URGENT-FIELD SAFETY NOTICE
2015-03-09

Subject: Suction module (Auxiliary O₂ & Suction module) sometimes can't be activated

UPDATE INSTRUCTIONS MCC/15/001/IU

TITLE: HARDWARE UPDATE AUXILIARY O₂ AND SUCTION MODULE

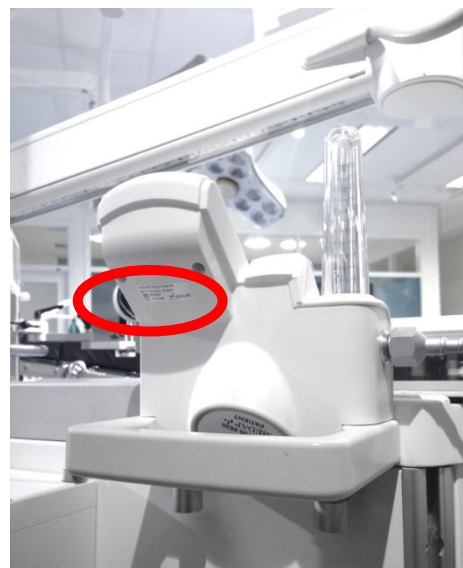
Affected product: Auxiliary O₂ and Suction Module – P/N 66 79 847

Affected units: S/N 00000001 - 00000925

A MAQUET serial number label is attached on the backside of the module.

In January 2013 a revised version of the suction module was released. One of the components that were changed was the On/Off function of the module. During 2014 complaints has been received with the symptom that the On/Off function not always was working. During investigation of some of the returned units it was detected that an internal O-ring could slip off the valve and by that cause an obstruction of the drive gas to the suction unit. This has been corrected by changing both the valve and the valve seat. A Device Correction letter / Field Safety Notice describing this issue, has been distributed to all concerned users.

P/N 68 83 730 Exchange Auxiliary O₂ and Suction module

P/N 68 83 730 Exchange Auxiliary O₂ and Suction module, includes one Auxiliary O₂ and Suction Module, one filter and two screws. No tubing or handle is included.
